Product Change Notification

Product Group: SIL/Friday July 31, 2026/PCN-SIL-061-2026-REV-0

Commercial Power MOSFET Manufacturing Capacity Expansion for D2PAK (TO-263-7L) Package

VERSION 1: FACILITY CODE = T

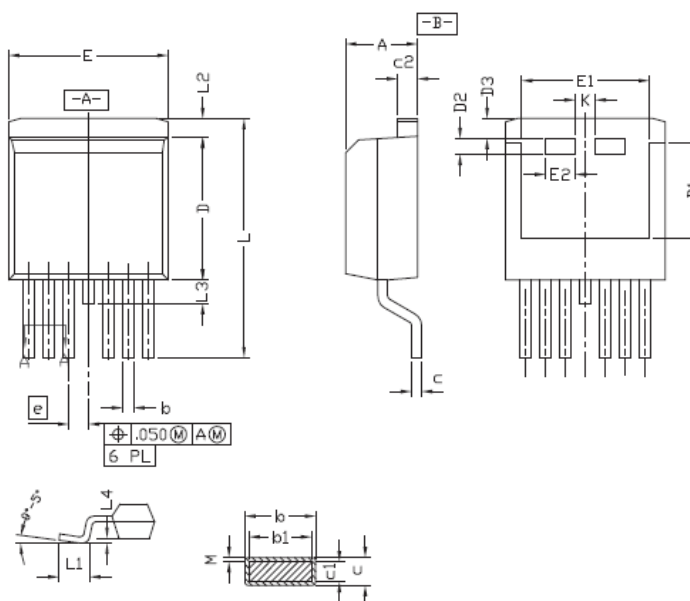
Description of Change: Vishay Siliconix announces the B/E site-transfer from KHH site to ATX Weihai as the capacity expansion of assembly and testing for Commercial Low-Voltage Power MOSFET in D2PAK package (TO-263-7L).

Expected Influence on Quality/Reliability/Performance: There will be no effect on the quality, reliability, and performance; no changes in minimum and maximum values on the datasheet parameters. PAD Pattern are compatible while the package drawing and outlooking will follow the official document Doc#63782, "D2PAK (TO-263-7L) Case Outline".

Product Identification: Products manufactured at ATX will be identified by the factory code "N" on the top-marking.
